Typos and Mistakes Found in *Practical Electronics for Inventors*, 2nd ed., by Paul Scherz (McGraw-Hill, 2007)

This list is being compiled by Martin Ligare during the spring semester of 2008 during the teaching of an Applied Electronics course at Bucknell University. This list does not cover the entire text — for the most part it covers portions of the text that are most relevant to the subject matter that has been covered to date in the class. This list will be updated during the semester; the last changes were made February 29, 2008. This document is available at `http://www.eg.bucknell.edu/physics/ph235/`. Additional material for this list should be sent to `mligare@bucknell.edu`.

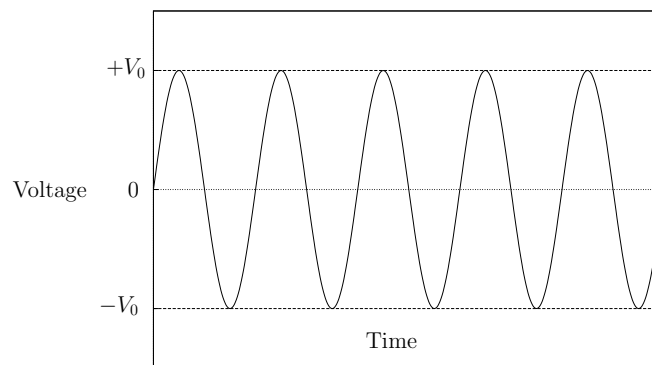
- Section 2.20, including Figs. 2.77, 2.80, 2.82, 2.84, 2.85; Section 2.21, discussion on p. 87 and Figs. 2.86 and 2.87: Scherz uses the term *amplitude* in non-standard way. The *amplitude* of a sinusoidal waveform is conventionally the largest value of the waveform; in the following illustration the amplitude of the voltage signal is V_0.

(The *peak-to-peak* amplitude is $2V_0$, and the *RMS* amplitude is $V_0/\sqrt{2}$.)
